STATE OF CONNECTICUT
CONNECTICUT SITING COUNCIL

IN RE: :
 :
 :
 PETITION OF PAWCATUCK SOLAR : PETITION NO. 1345
 CENTER, LLC FOR A DECLARATORY :
 RULING THAT A CERTIFICATE OF :
 ENVIRONMENTAL COMPATIBILITY AND :
 PUBLIC NEED IS NOT REQUIRED FOR THE :
 CONSTRUCTION, OPERATION AND :
 MAINTENANCE OF A 15 MW AC SOLAR :
 PHOTOVOLTAIC PROJECT ON ELLA :
 WHEELER ROAD IN NORTH STONINGTON, :
 CONNECTICUT : JULY 30, 2018

RESPONSES OF PAWCATUCK SOLAR CENTER, LLC
TO CONNECTICUT SITING COUNCIL INTERROGATORIES – SET ONE

E WETLAND CROSSING
SCALE: NTS

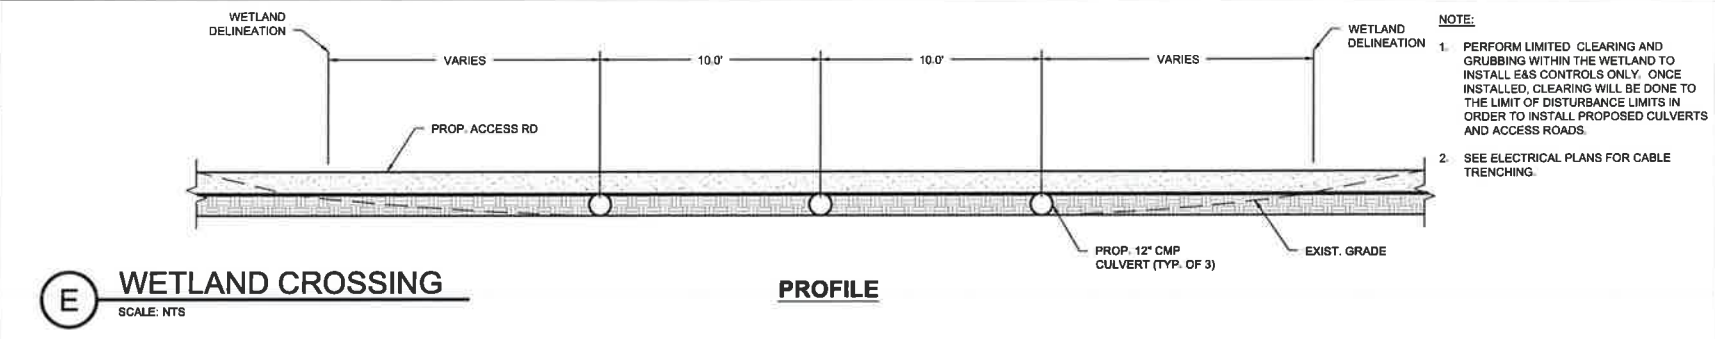
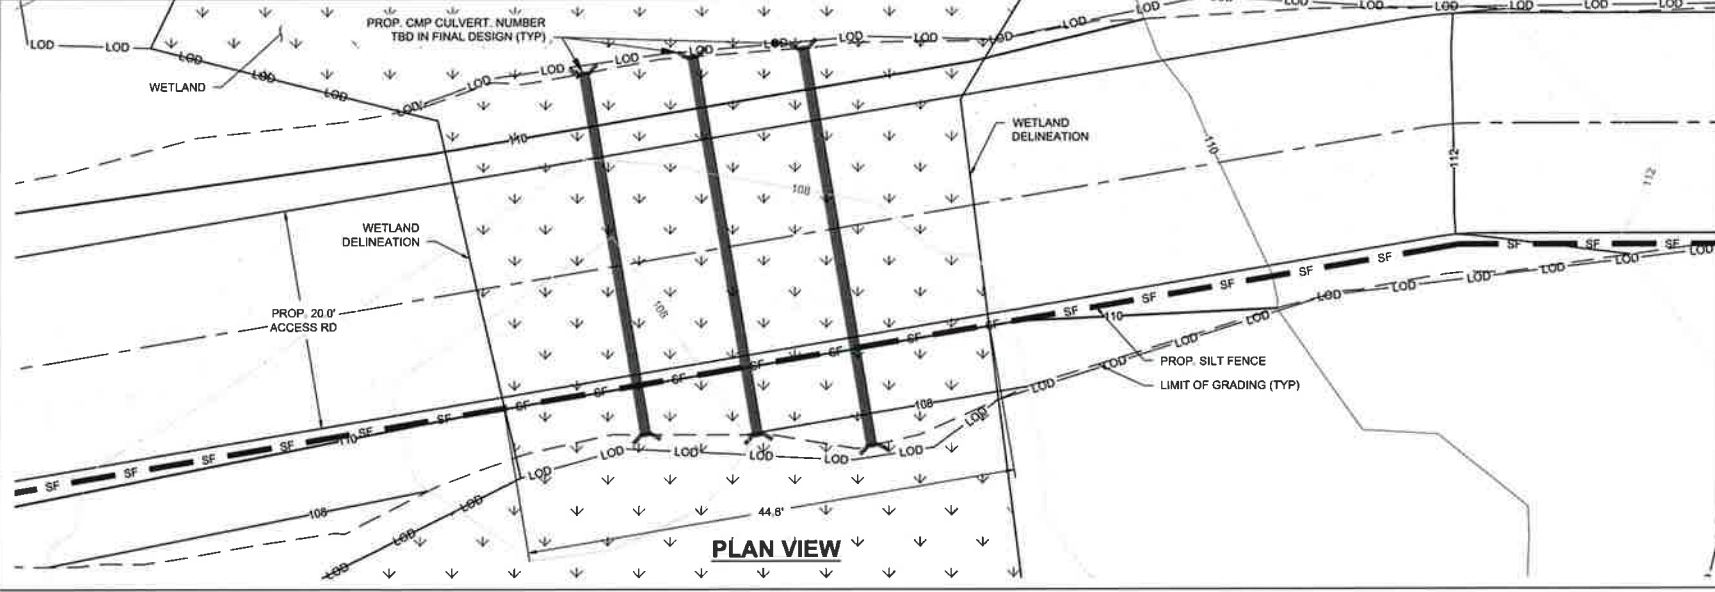
Referencing the June 25, 2018 DEEP comments on page 2, for the crossing of Wetland 1, at what point would the road cross the wetland? If the crossing is in the area of concern in the comments, could the road crossing be moved to the north or south? Provide a drawing detail for the crossing area.

At least a portion of the proposed crossing location in Wetland 1 would occur within 'dense' vegetation noted on page 2 of the referenced June 25, 2018 DEEP comment letter. The road crossing could be shifted slightly to the north or south to avoid this dense vegetation area. This slight shift in the road crossing of Wetland 1 could be made in the field during construction at the direction of an Environmental Monitor based on actual field conditions. It is anticipated that this slight shift would not substantially change the wetland impacts associated with the proposed road crossing by more than 100 square feet. A detail drawing of the proposed wetland crossing is provided in an updated set of Grading and Drainage Plans, dated April 18, 2018 included in Attachment 12. Four (4) full size (24" x 36") sets of the Updated Grading and Drainage Plans are also attached as a bulk file exhibit.

PROJECT: PAWCATUCK SOLAR CENTER
 DRAWING TITLE: EROSION & SEDIMENTATION PLAN - AREA NORTH EAST
 DRAWING NO. C-701

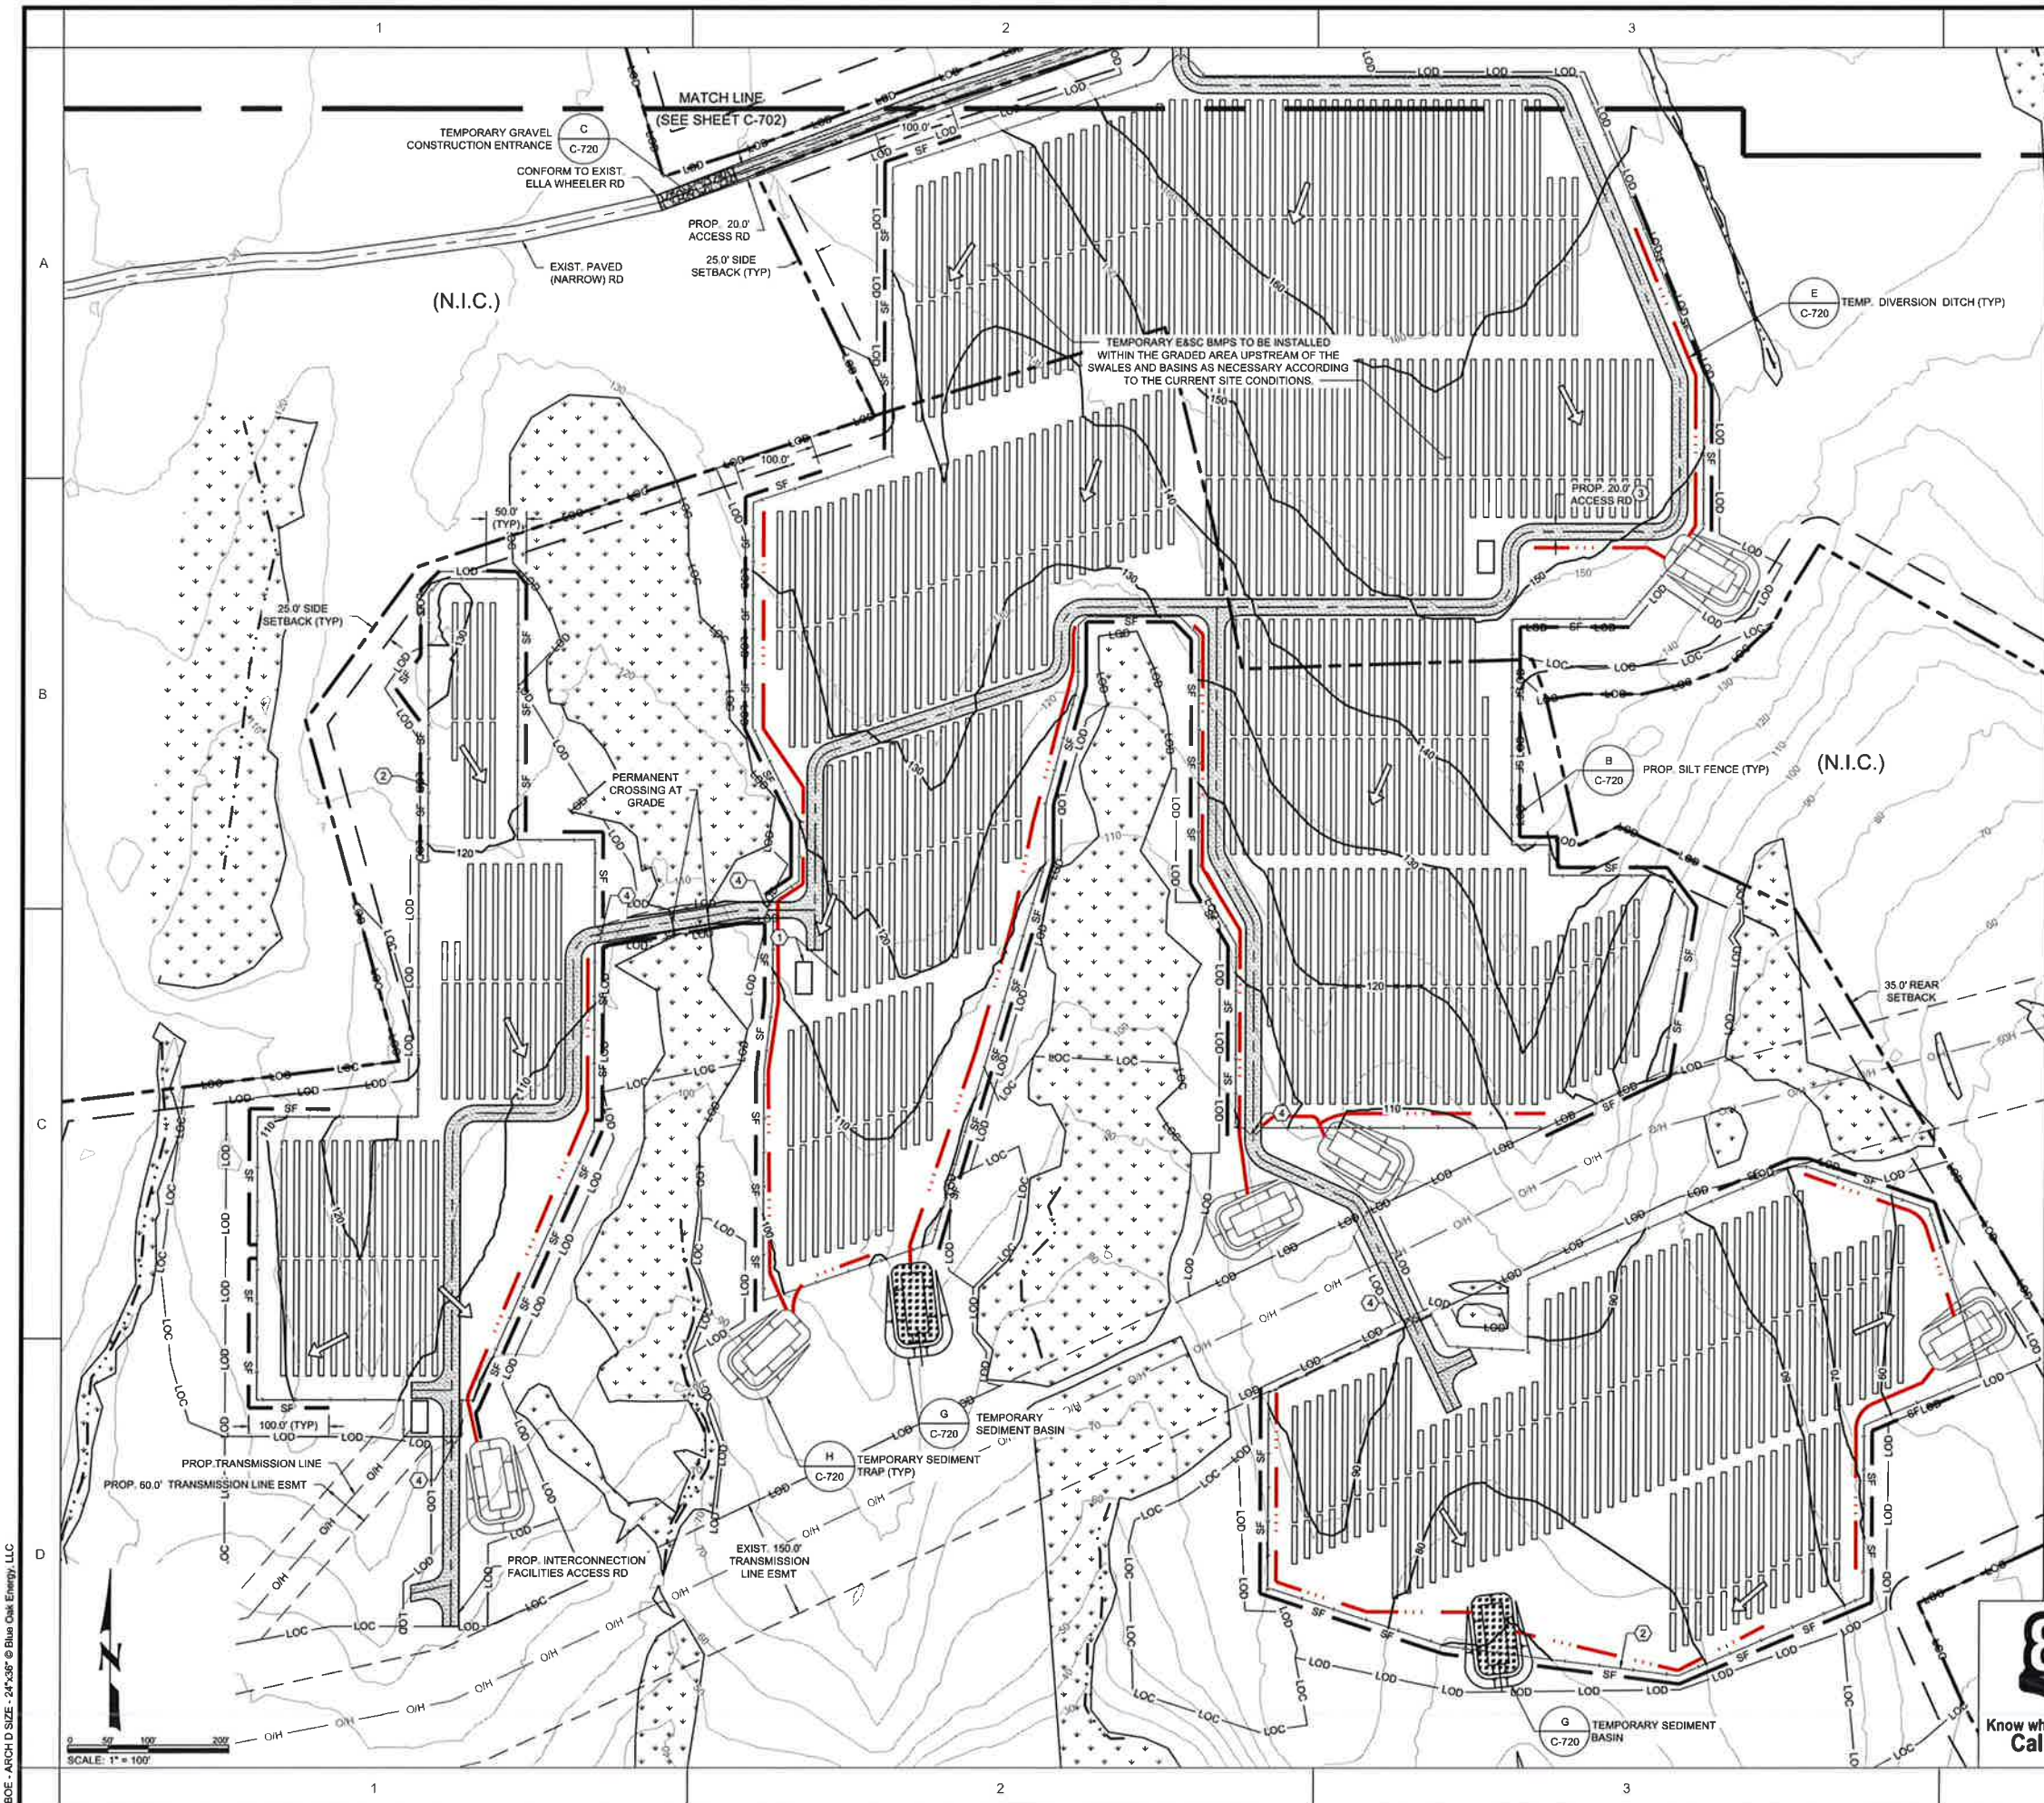
Petition Exhibit C - Sheet 701 depicts fiber rolls along the hillside that terminate at proposed solar array access ways. What is preventing stormwater from flowing downslope along the fiber rolls then directly down each access way? Assuming the access ways would be rutted by vehicles, could this cause direct, high velocity channelization?
